Meeting Agenda Planning Commission

Wednesday, May 13, 2020

**TECHNICAL REVIEW PLAT REQUIREMENTS
REGULAR PLANNING COMMISSION MEETING
MAY 13, 2020**

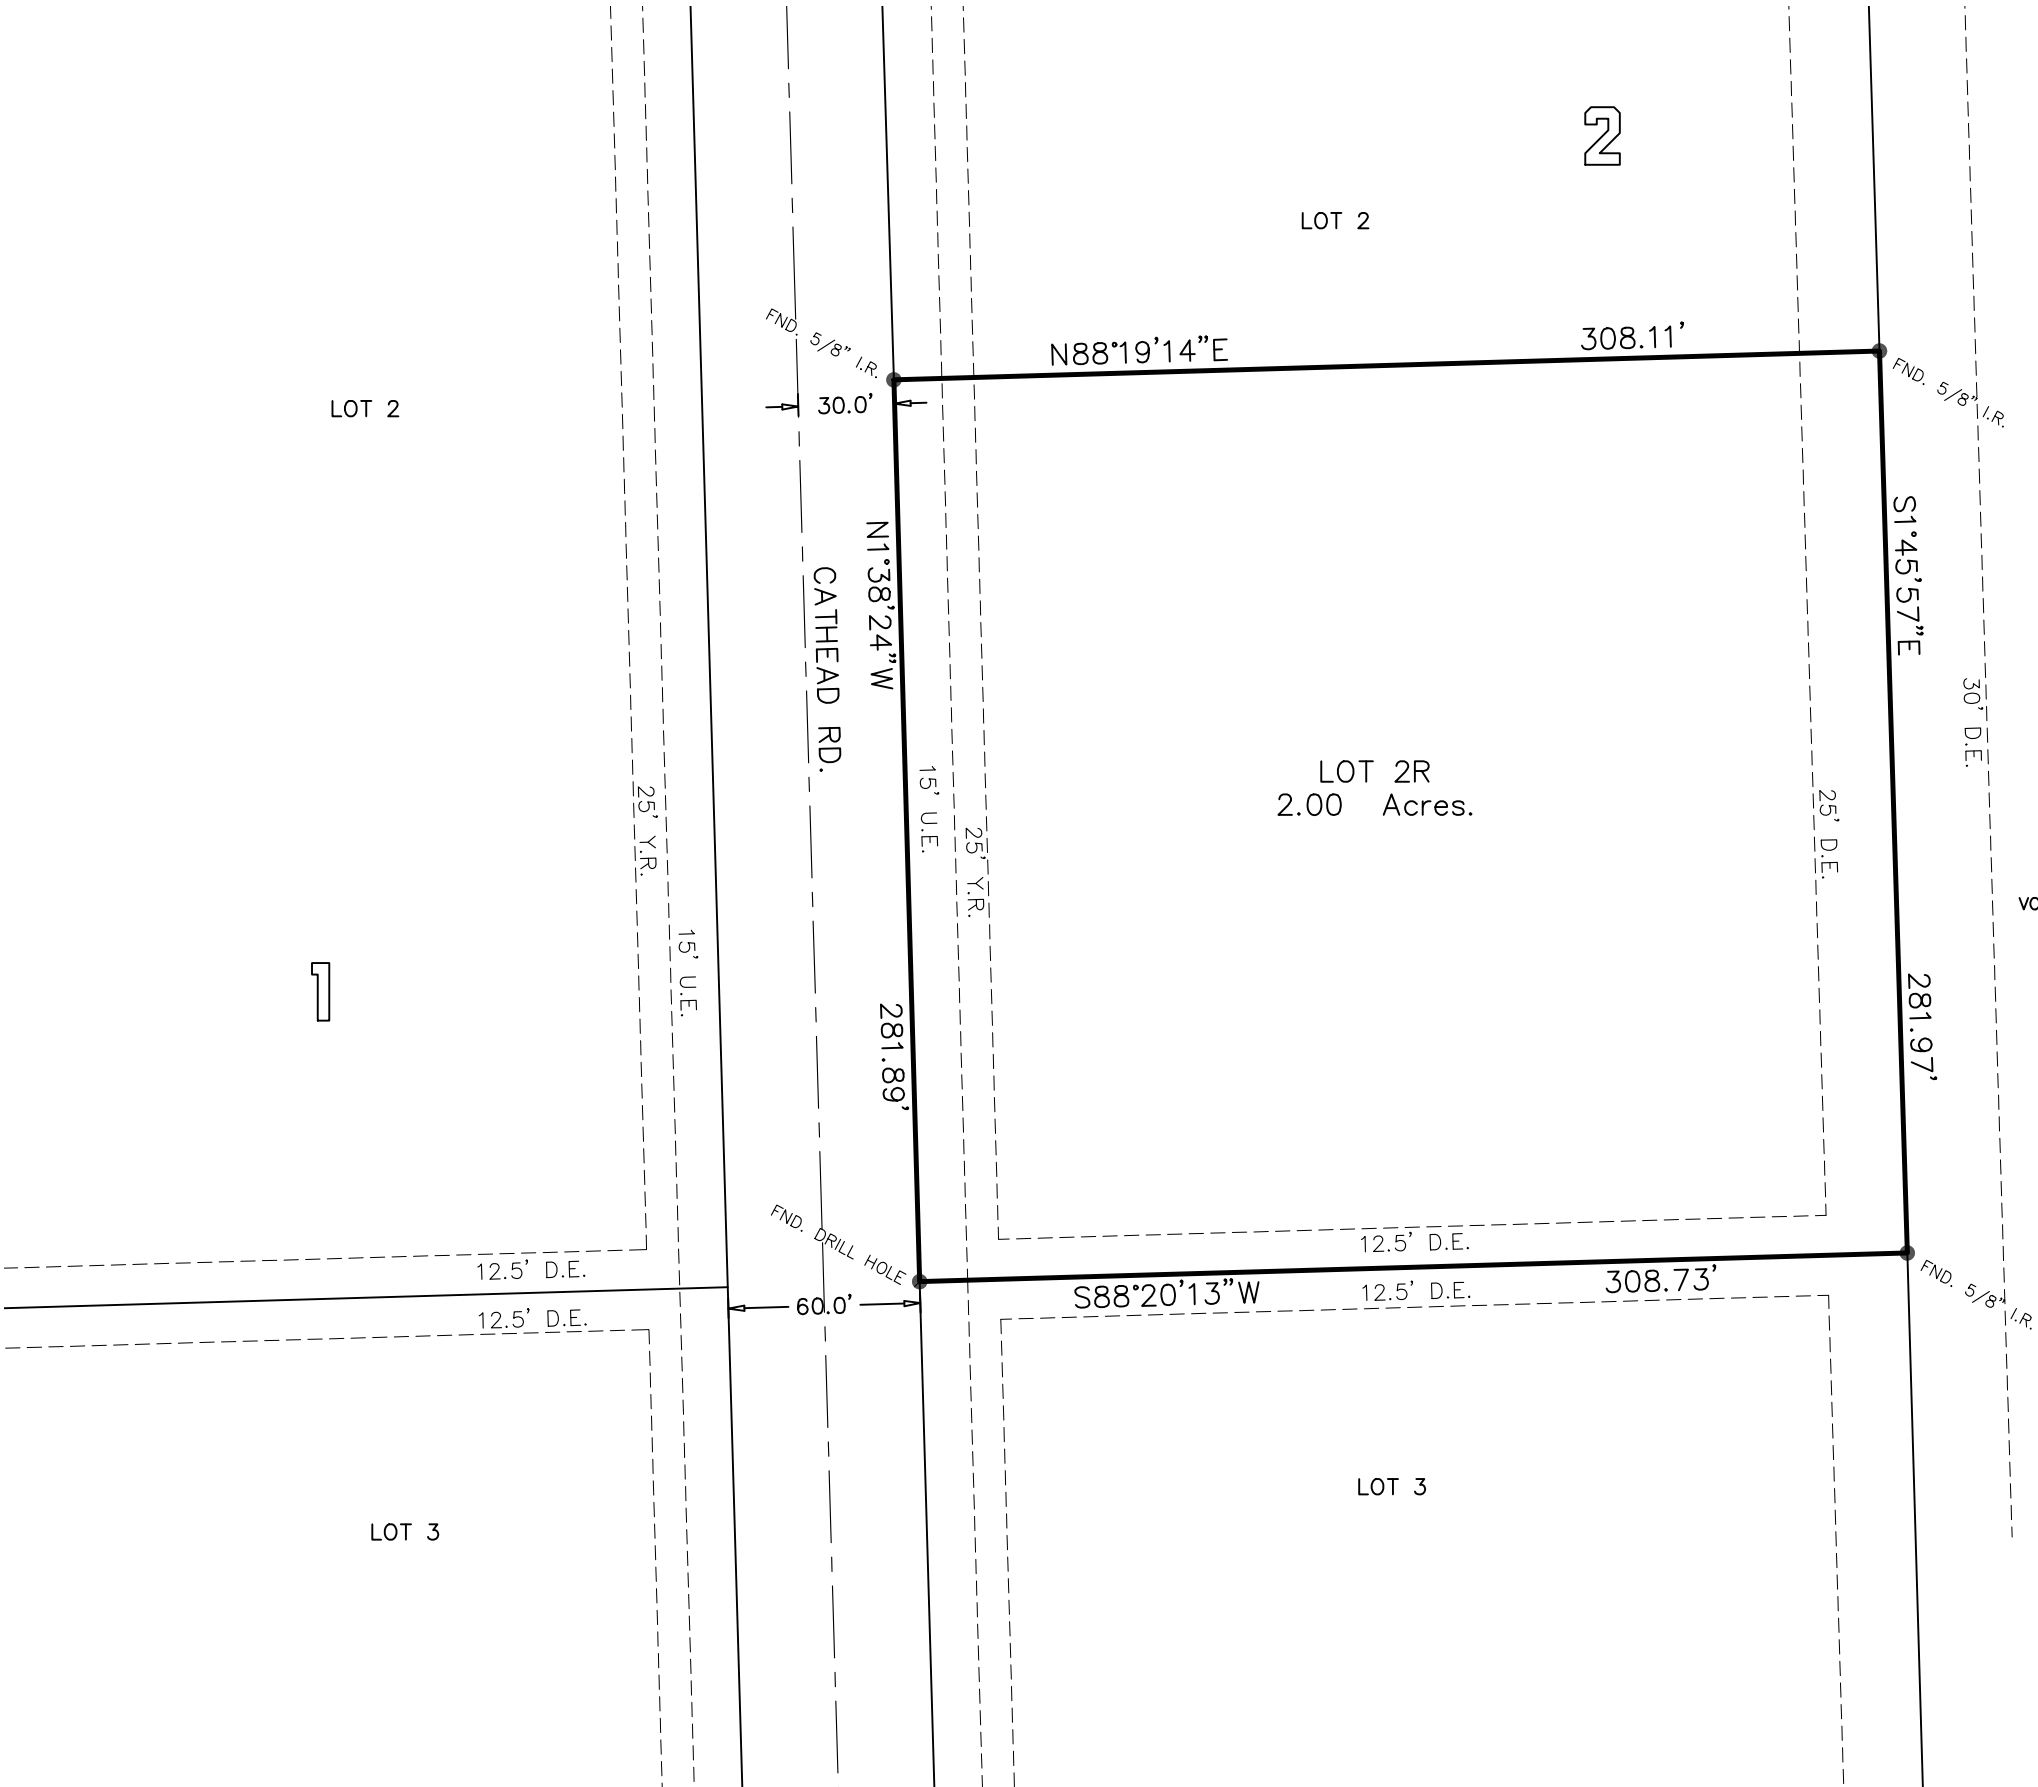
GIS						
No.	Sheet	Comment	Applicant Response	Staff Resolution	Applicant Response	Staff Resolution
1	Plat	The plat closes within acceptable engineering standards.		Addressed		
2	Plat	Provide a north arrow on the location map.		Not addressed. No response.	ADDED NORTH ARROW	Addressed

LAND DEVELOPMENT						
No.	Sheet	Comment	Applicant Response	Staff Resolution	Applicant Response	Staff Resolution
1	Plat	Update plat description with "South half" and correct spelling of Wildcat.		Not addressed. No response.	CORRECTED	Addressed
2	Plat	Update DS Engineer certificate with Jalal Saleh, PE		Not addressed. No response.	DONE	Addressed
3	Plat	Remove plat note 8 from plat.		Addressed		
4	Plat	Show the 30' DE at rear on adjacent property as per previous plat.		Not addressed. No response.	ADDED	Addressed
5	Plat	Development fees paid on previous plat.		Addressed

No.	Sheet	Comment	Applicant Response	Staff Resolution	Applicant Response	Staff Resolution
1	Plat	Remove plat note 8.	REMOVED	Addressed

Plat of
Westpoint Crossing Unit 2
Block 2, Lot 1

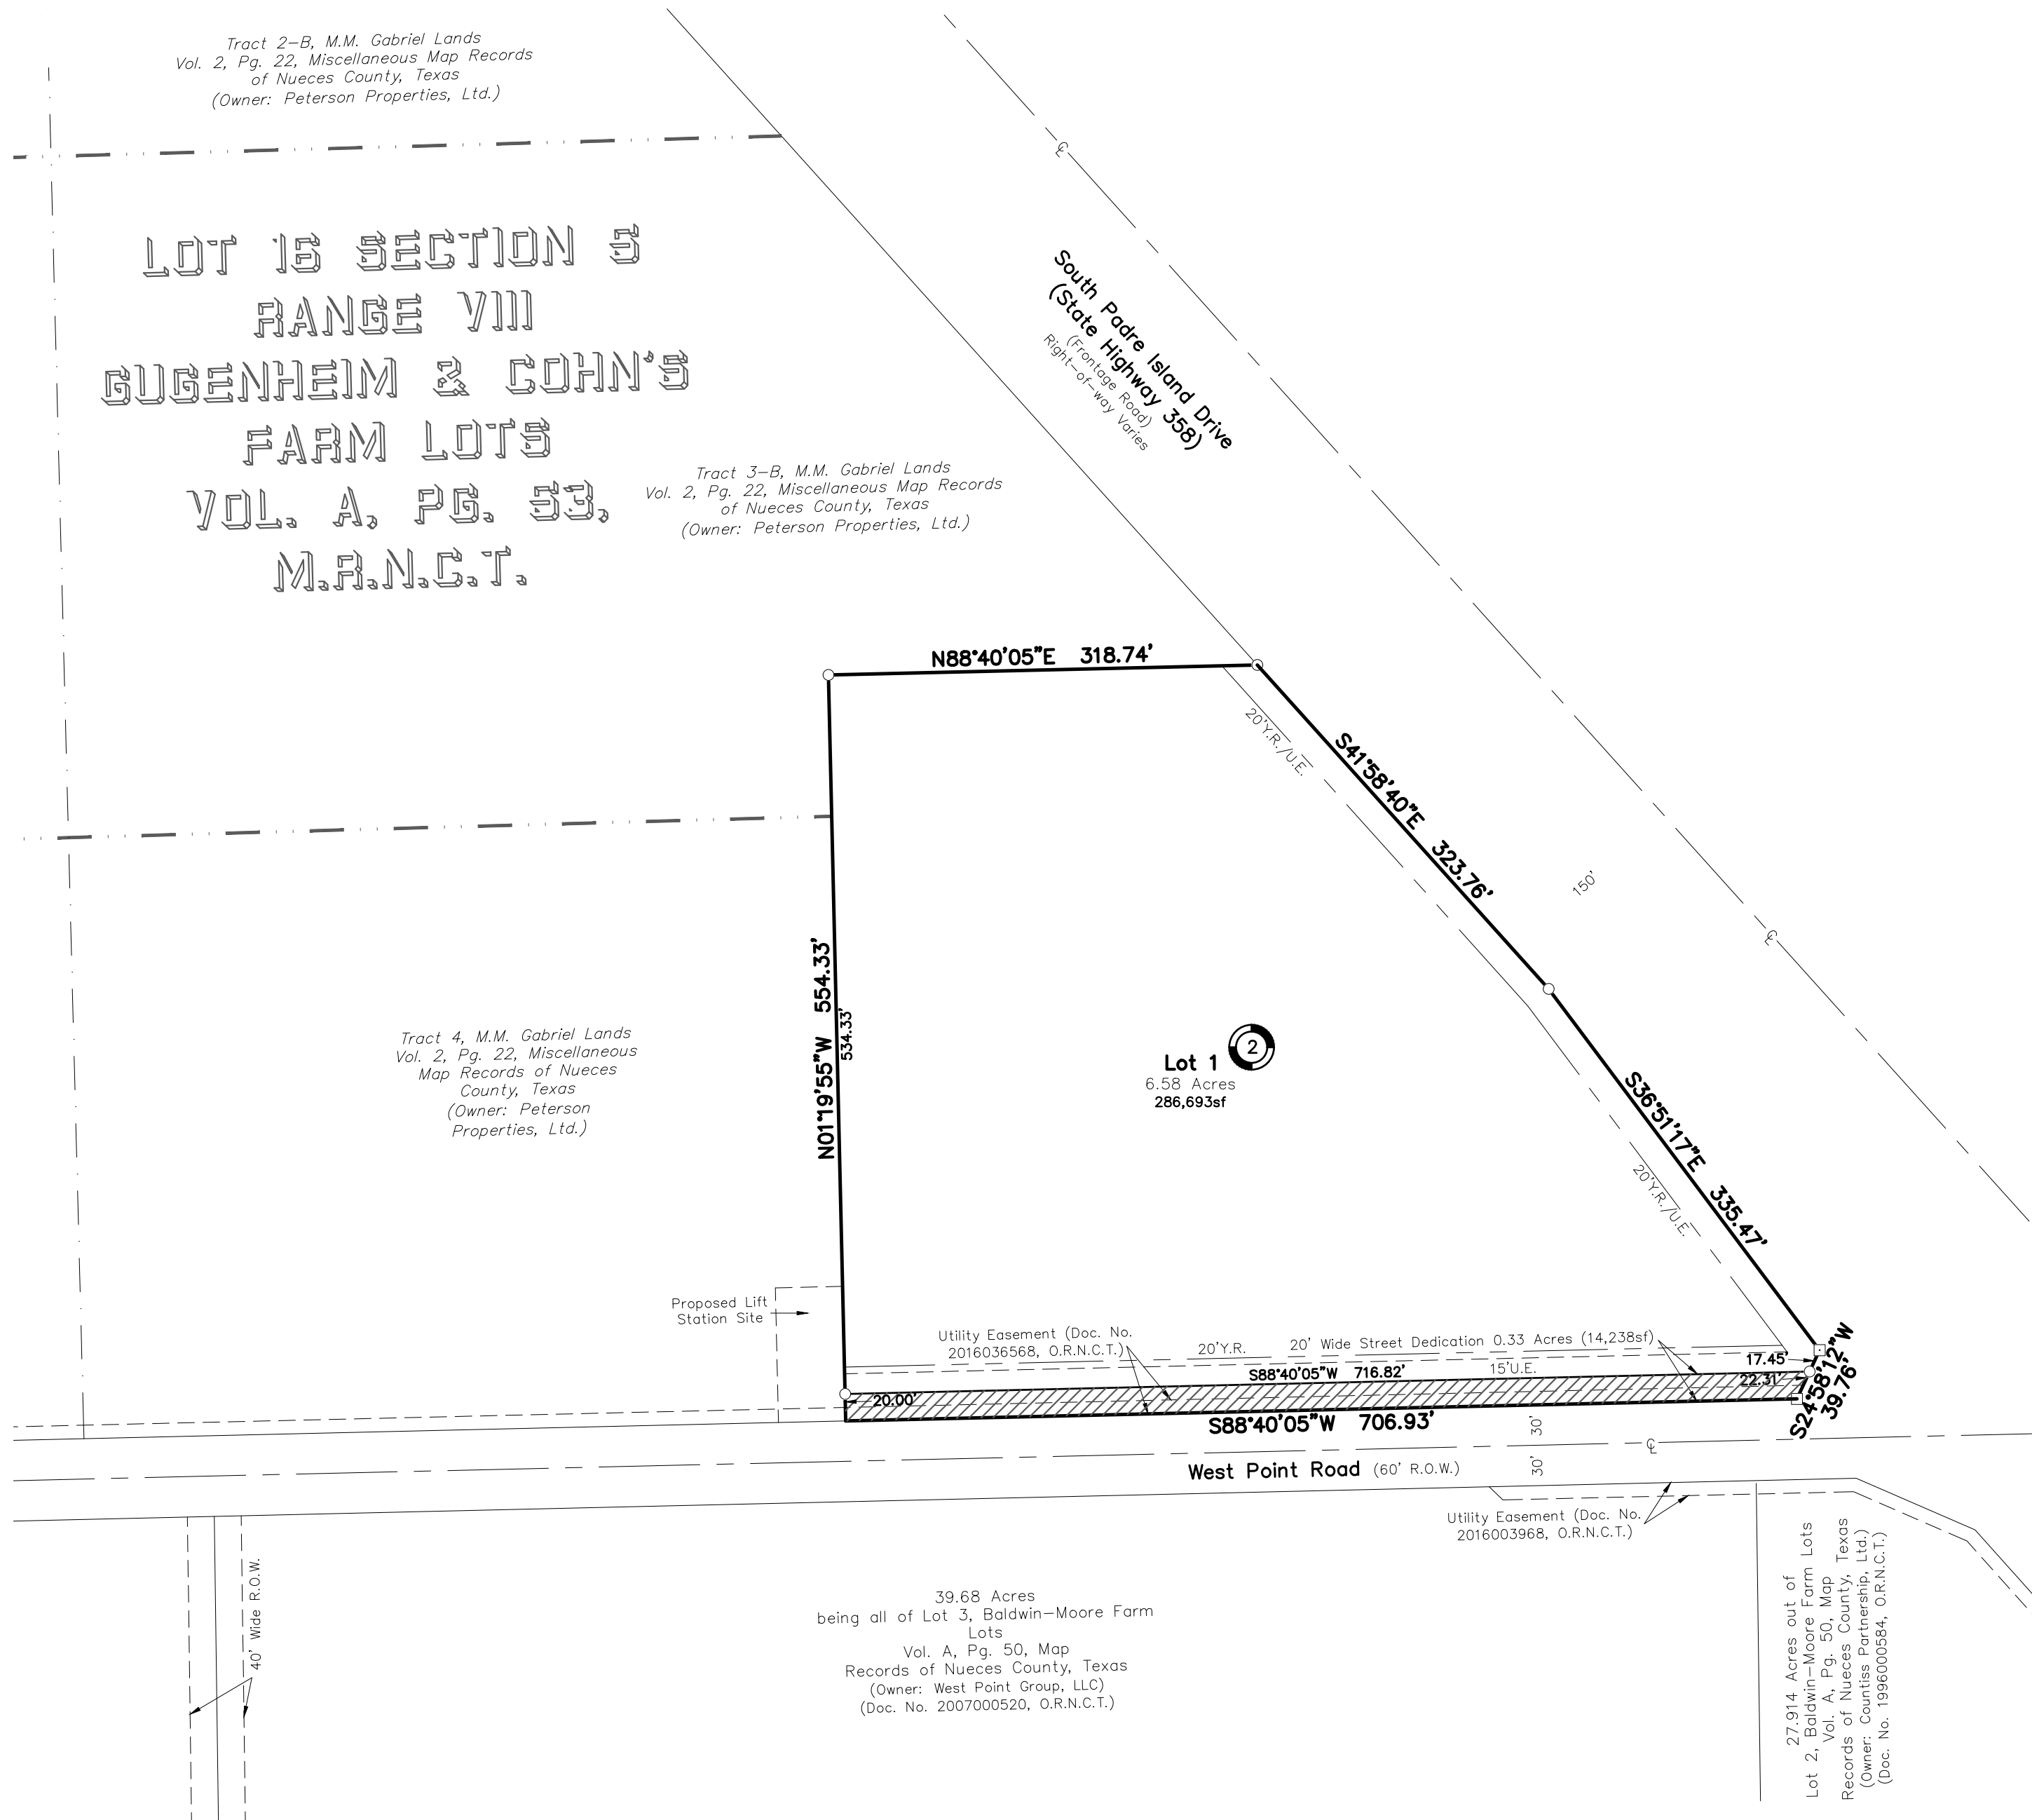
GIS						
No.	Sheet	Comment	Applicant Response	Staff Resolution	Applicant Response	Staff Resolution
1	Plat	The plat closes within acceptable engineering standards.	Understood	Addressed.

LAND DEVELOPMENT						
No.	Sheet	Comment	Applicant Response	Staff Resolution	Applicant Response	Staff Resolution
1	Plat	Remove dashed line within property that is the boundary of Tract 3-B and Tract 4.	has been removed	Addressed.		
2	Plat	Proposed Lift station Site to be shown as a Public easement. Provide document number or include in platted area.	Lift station site will be deeded to the city. Recording information will be shown on deed has been filed.	To be addressed prior to recordation		
3	Plat	Water Acreage fee= 6.58 Acres x \$1,439.00 = \$9,468.62	understood	To be addressed prior to recordation		
4	Plat	Waste water Acreage fee= 6.58 Acres x \$1,571.00 = \$10,337.18	understood	To be addressed prior to recordation

DEVELOPMENT SERVICES ENGINEERING						
No.	Sheet	Comment	Applicant Response	Staff Resolution	Applicant Response	Staff Resolution
1		Public Improvements Plans are required for water and wastewater main prior to plat recordation; submit a pdf copy of proposed public improvements along with a title sheet to PublicImprovements@cctexas.com for review and approval; this item is required prior to Final Plat Recordation. UDC 8.1.3.A	understood	To be addressed prior to recordation		
2	Utility Plan	Show and label the proposed Private Wastewater Lift Station and wastewater main; keep in mind the conversation you had with Mr. Michael Johnston, no reimbursement is allowed for a VA (government project).	This is just wrong. It is a master plan lift station and is eligible for reimbursement as it will serve additional properties. In addition, the VA Clinic facility is privately owned and leased to the government.	Not Addressed: You need to address this item With Mr. Michael Johnston. To be addressed prior to recordation.

3	Utility Plan	Please don't place the proposed FH at the stormwater crossing on West Point Road.	Understood, please see attached revised utility plan.	Addressed.		
4	Plat	Provide a cross access easement between lots 1 and 2.	No, Not necessary or required	Addressed.		
5	Plat	Add the following note "all driveways on West Point Road shall conform to access management standards outlined in Article 7 of the UDC".	Note has been added	To be addressed on site development.		
6	Informational	See TXDOT Comments hereafter.	Understood	Addressed.

Plat of
Lindale Park Section 4
Block 40, Lot 23R

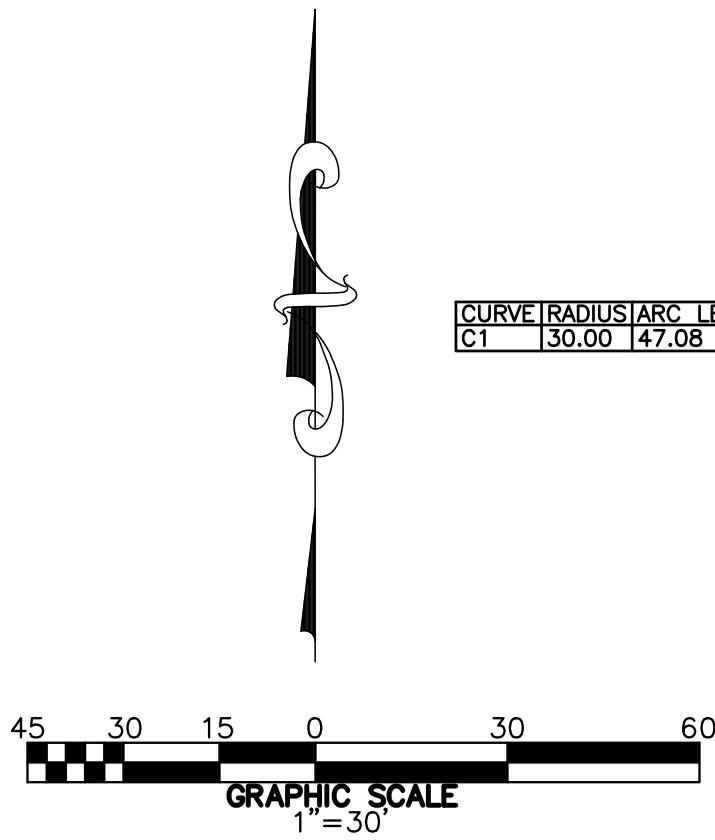
GIS						
No.	Sheet	Comment	Applicant Response	Staff Resolution	Applicant Response	Staff Resolution
1	Plat	The plat closes within acceptable engineering standards.	Understood	Resolved.		
2	Plat	Please fix Legal description grammatical error. (Volume 11, Page* 14)	Correction has been made	Resolved.		
3	Plat	The plat title will begin with the subdivision name, followed by the block number then the lot number.	Correction has been made	Not Resolved. Plat title should reflect proposed lot number (23R)	Correction has been made	Resolved.

No.	Sheet	Comment	Applicant Response	Staff Resolution	Applicant Response	Staff Resolution
1	Plat	Change the BL to Y.R. for Yard Requirement.	Change has been made	Addressed.		
2	Plat	Provide a 10' UE along Texas Trail.	Easement has been added	Addressed.		
3	Plat	Provide an extra 5' UE along the west boundary.	No, We have provided an additional 2.5 Feet of U.E. which would account for our portion of the Required 15' U.E. by U.D.C.	Not Addressed. For 5' UE provide previous plat reference. Label additional as 2.5' and provide a dimension for the 7.5'.	Label has been added and correction was made.	Addressed.
4	Plat	On plat title, place block before the lot number.	Correction has been made	Addressed.		
5	Plat	Water Distribution System acreage fee – 0.91 acres x \$1,439.00/acre = \$1,309.49	Understood	To be addressed prior to recordation.		
6	Plat	Wastewater System acreage fee – 0.91 acres x \$1,571.00/acre = \$1,429.61	Understood	To be addressed prior to recordation.

1		Add the following standard "Public Open Space" standard note: "If any lot is developed with residential uses, compliance with the open space regulation will be required during the building permit phase."	Note has been added	Addressed.		
---	--	---	---------------------	------------	--	--
